Technical Service Bulletin

Topic	E-Machine temperature fault DTC P0A2E00 Bentayga and Flying Spur (Hybrid) 20-23MY
Market area	Bentley: worldwide (2WBE),China 796 VW Import Comp. Ltd (Vico), Beijing (6796)
Brand	Bentley
Transaction No.	2077783/1
Level	EH
Status	Released for publishing
Release date	May 22, 2025

Figure 1

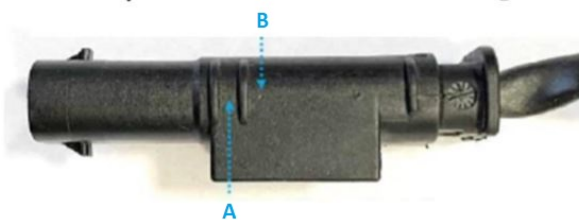
Use figure 1 to help identify old and new level parts. Pay particular attention to the markings shown.

Markings shown by **A** (*indentation between the rib*) = New level parts

Markings shown by **B** (*Indentation to the right of the rib*) = Old level parts

3. Install the new level electric drive temperature sensor.
